ULNRC-04187
TAC NO. MA8052

**DOCKET NUMBER 50-483
CALLAWAY PLANT
UNION ELECTRIC COMPANY
SUPPLEMENT TO REQUEST FOR PROPOSED REVISION
TO TECHNICAL SPECIFICATIONS
TO CORRECT EDITORIAL ERRORS**

MARKED-UP PROPOSED IMPROVED TECHNICAL SPECIFICATIONS

Table of Contents, Page 3

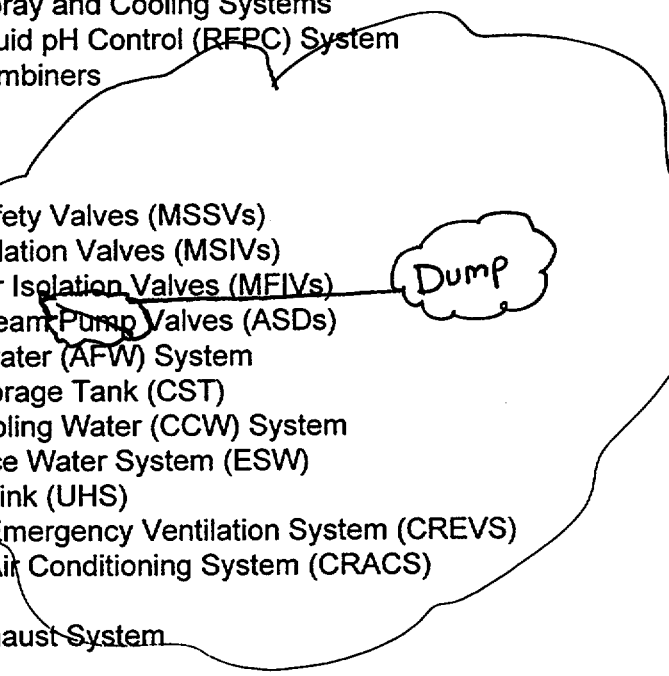
1. **Table of Contents, page 3. Section 3.7.4** - The word "Pump" should be "Dump". The Table of Contents was not originally provided in the ITS submittal in ULNRC-3578 dated May 15, 1997. The Table of Contents was provided in the certified copy of ITS transmitted in ULNRC-4044 dated May 27, 1999. The section title for Section 3.7.4 in the Table of Contents includes the word "Pump", when the correct word should be "Dump".

3.7.2	Main Steam Isolation Valves (MSIVs)	3.7-5
3.7.3	Main Feedwater Isolation Valves (MFIVs)	3.7-7
3.7.4	Atmospheric Steam Pump Valves (ASDs)	3.7-9
3.7.5	Auxiliary Feedwater (AFW) System	3.7-12

3.7.2	Main Steam Isolation Valves (MSIVs)	3.7-5
3.7.3	Main Feedwater Isolation Valves (MFIVs)	3.7-7
3.7.4	Atmospheric Steam Dump Valves (ASDs)	3.7-9
3.7.5	Auxiliary Feedwater (AFW) System	3.7-12

T/S 1.1, page 1.1-6

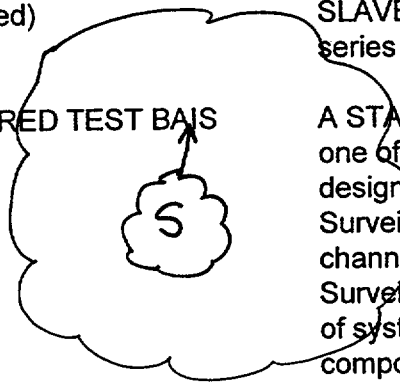
1. **Page 1.1-6.** Under 1.1 Definitions, the Term, STAGGERED TEST BAIS, the word “BAIS” should be corrected to “BASIS”. This word is misspelled in the certified copy due to a typographical error.

T/S 3.4.15, page 3.4-37

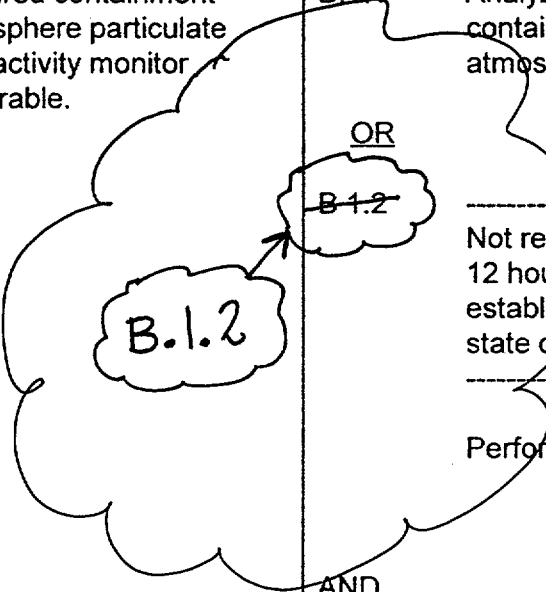
2. **Page 3.4-37.** Under REQUIRED ACTION, CONDITION B, the label “**B 1.2**” is missing the period between the B and the 1. The REQUIRED ACTION label is corrected to “**B.1.2**”. The omission of the period in the certified copy is due to typographical error.
